Application Request: Consideration and action on final approval of Uintah View Estates Subdivision, a 9 lot subdivision.
Type of Decision: Administrative
Agenda Date: Tuesday, March 12, 2019
Applicant: Jeremy Jaggi, Representative
File Number: LVU111318

UINTAH VIEW ESTATES

RE: Uintah View Estates Subdivision

Exhibit B – Subdivision Plat

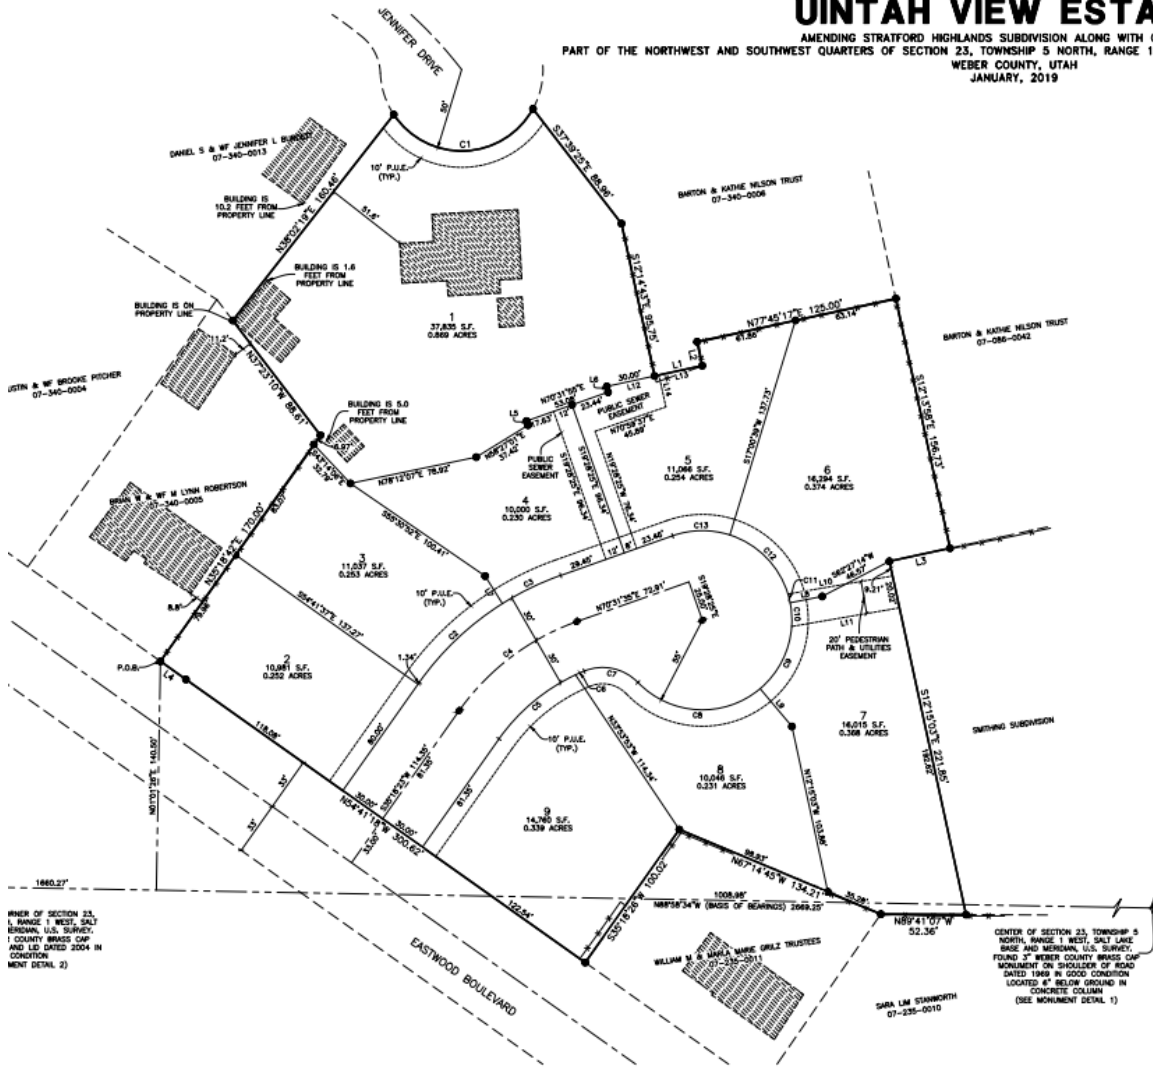
1. A paved, 6' wide walking path is required from E 5950 South to the proposed cul-de-sac shown on the subdivision plat.
2. Secondary water will be provided by
3. Improvements will either need to be installed, or escrowed for, prior to recording of this subdivision.
4. Perc test holes must be shown on the final plat.
5. A signature block for Uintah Highlands Improvement District must be included on the final plat.
